DRAINAGE AND TRANSPORTATION INFORMATION SHEET (REV 6/2018)

HOTEL ZAZZ
Heritage Hospitality Group
3711 Central Ave NE, Albuquerque, NM 87108

BUILDING PERMIT
SITE
PLAN

Re: Hotel Zazz
3711 Central Ave. NE
Traffic Circulation Layout
Engineer's/Architect's Stamp XX-XX-XX (K17-D121)

LS101

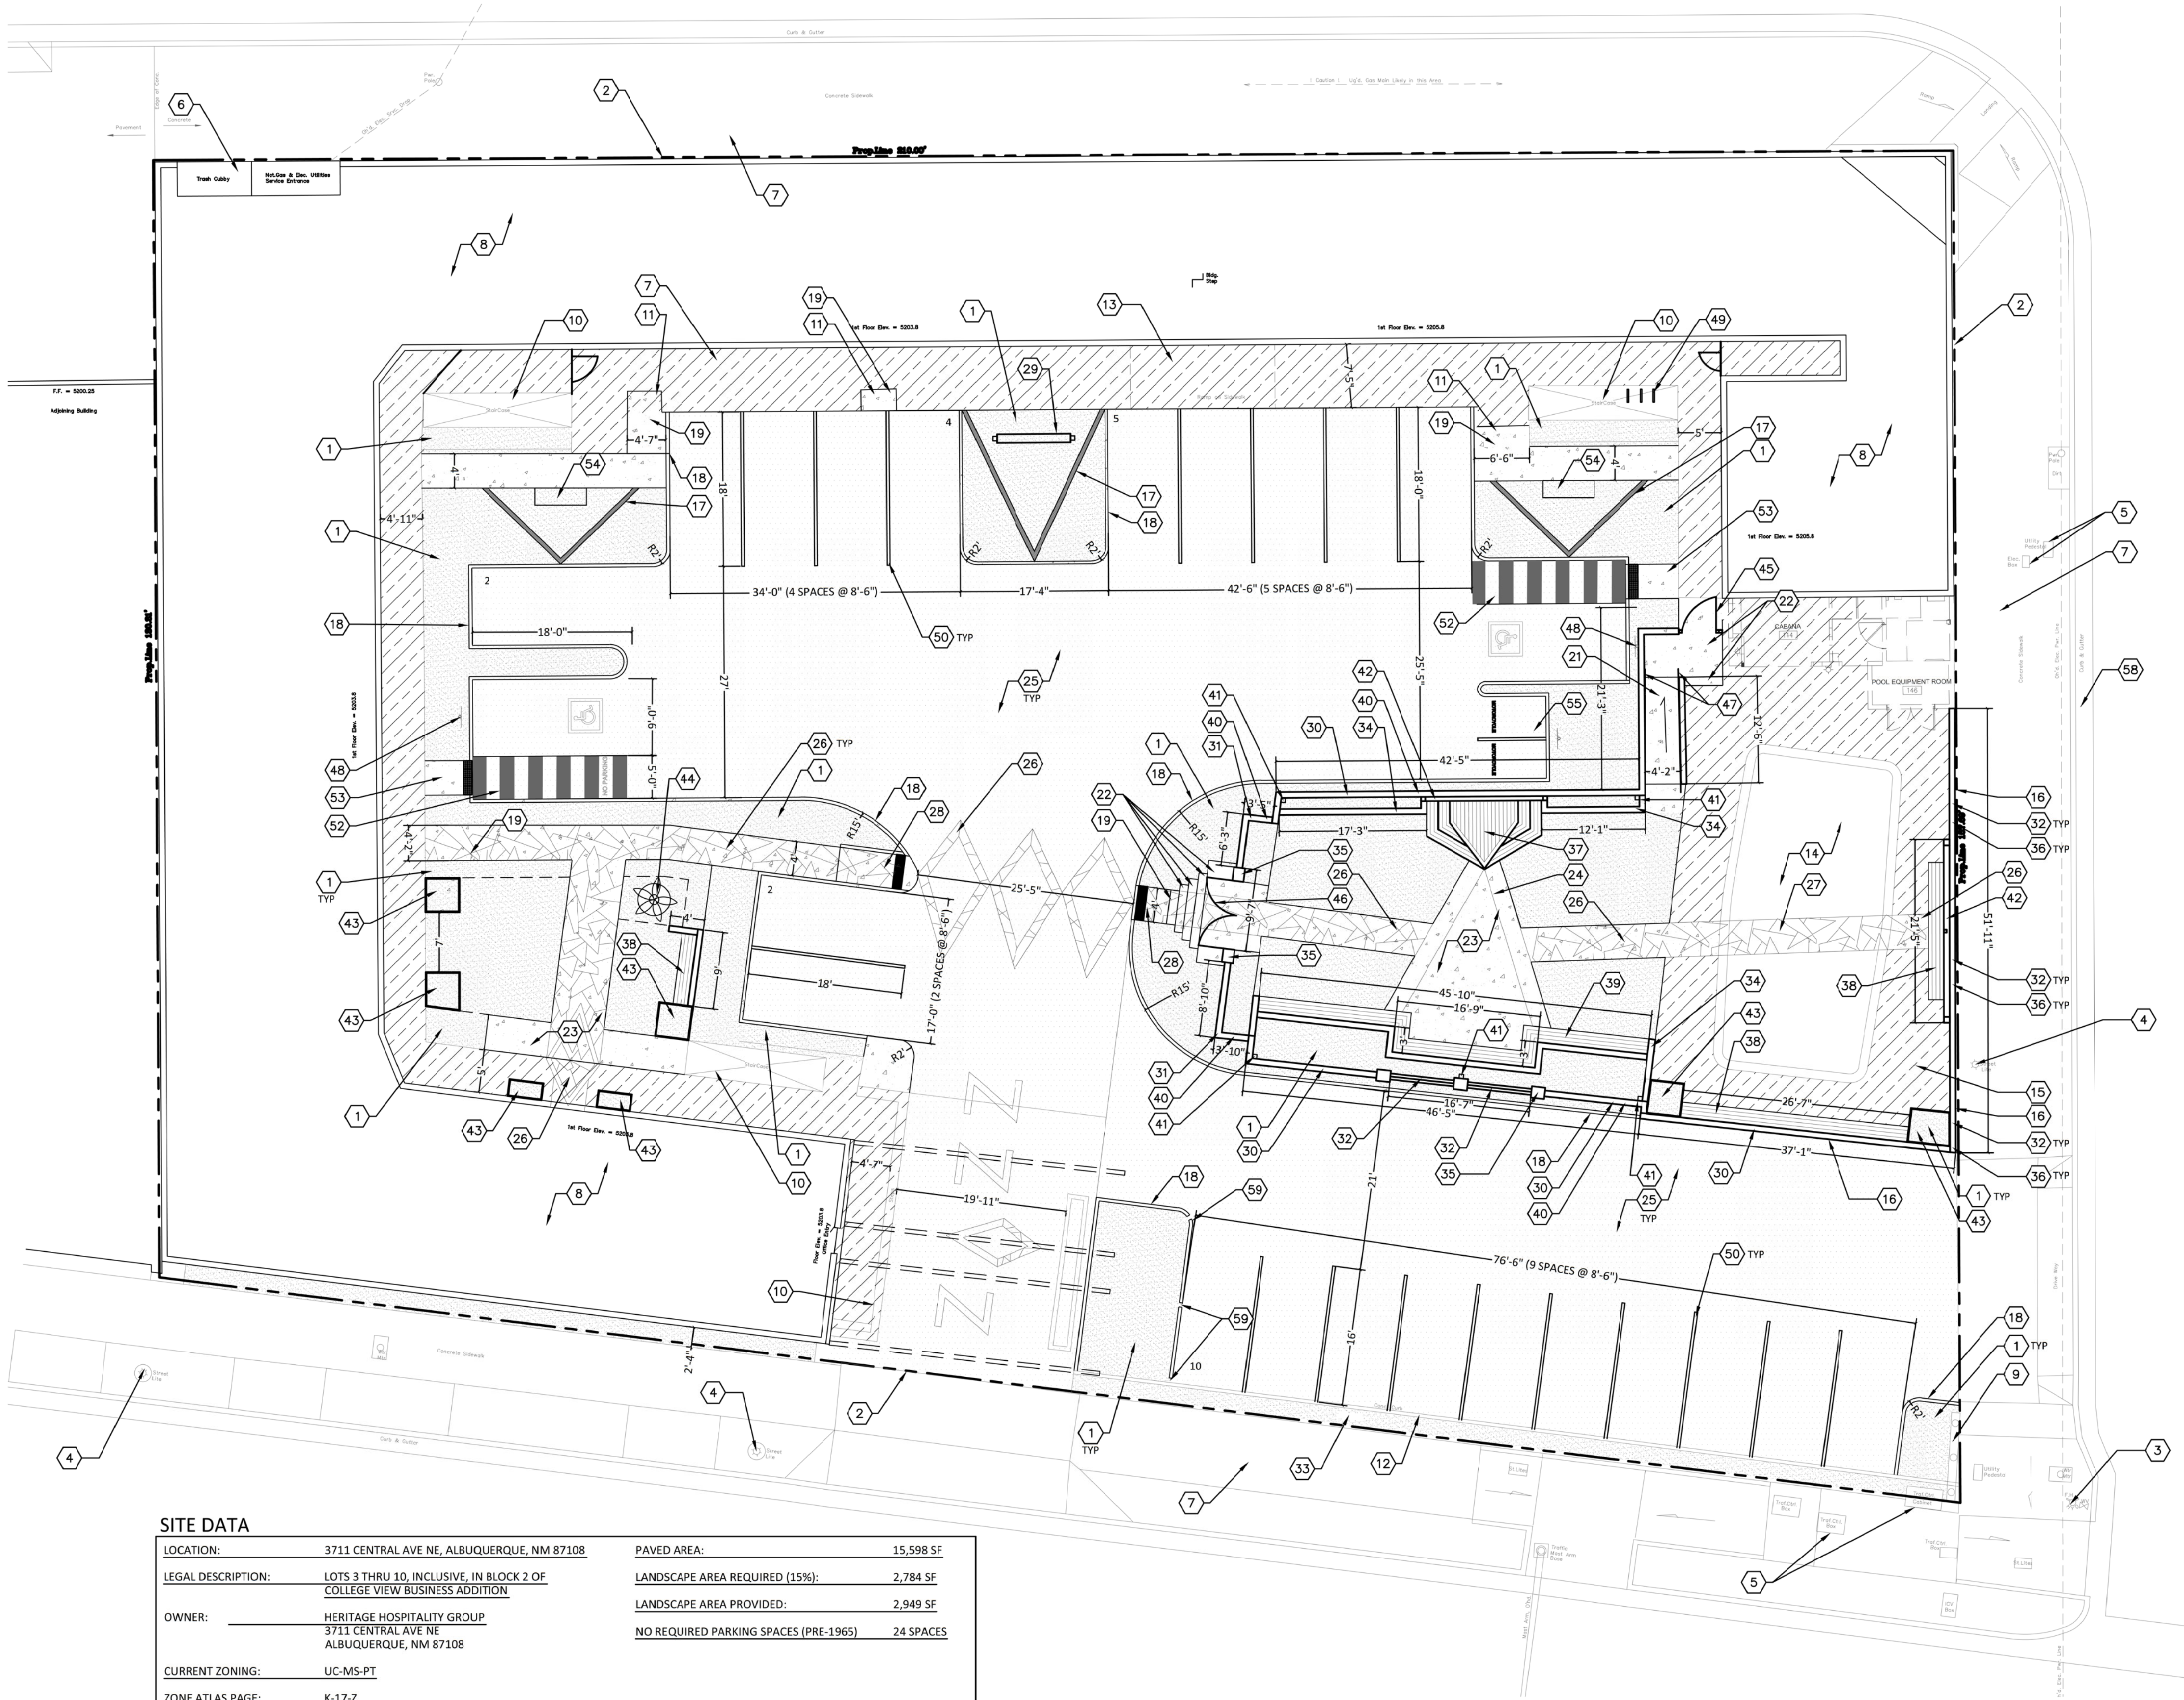
1. The traffic circulation layout must be stamped, signed, and dated by an engineer or architect licensed in the state of New Mexico.
2. The ADA accessible spaces must include an access aisle. Van accessible aisles should be 8ft wide; all others should be 5ft wide.

3. Per DPM, a 6 ft. wide ADA accessible pedestrian pathway is required from EACH ADA parking stall access aisles to the building entrances. Please clearly show this pathway and provide details.

4. ADA accessible pedestrian pathway should not be placed behind parking space or adjacent to a vehicular way. Vehicle and pedestrian/wheel chair conflicts should be avoided as much as possible.

5. Provide signs details for the ADA parking spaces.
6. Details sheet is missing, and please provide details for existing and proposing ADA ramps referring COA std dwg.

7. Refuse vehicle maneuvering shall be contained on-site. The refuse vehicle shall not back into the public right of way.; provide a copy of refuse approval.

8. Provide a copy of Fire Marshal Approval.
9. Add a note stating "All broken or cracked sidewalk must be replaced with sidewalk and curb & gutter." A build note must be provided referring to the appropriate City Standard drawing.

10. Please provide a letter of response for all comments given.
